**Ashtray Latch Malfunction –
 Revised Latch –
 Replacement Procedure**

MODEL 2000-01 MY
 S-TYPE

VIN L00001-L86902

ILLUSTRATION 3

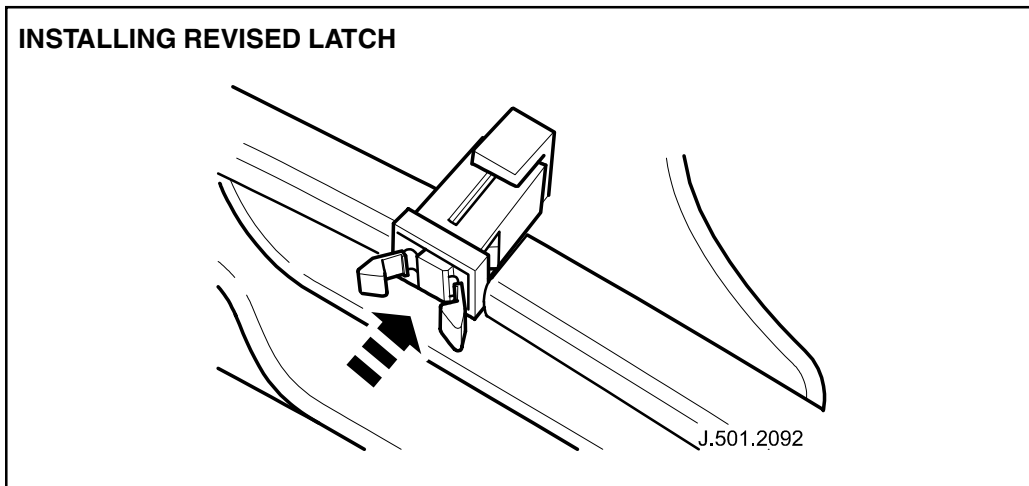
A revised ashtray latch has been introduced into production from VIN L86902. This latch can be installed on cars prior to this VIN that experience this customer complaint.

6. Push the revised latch into position (Illustration 3).

Note: If the latch claws are not in the open position, press the center of the latch mechanism to release the claws.
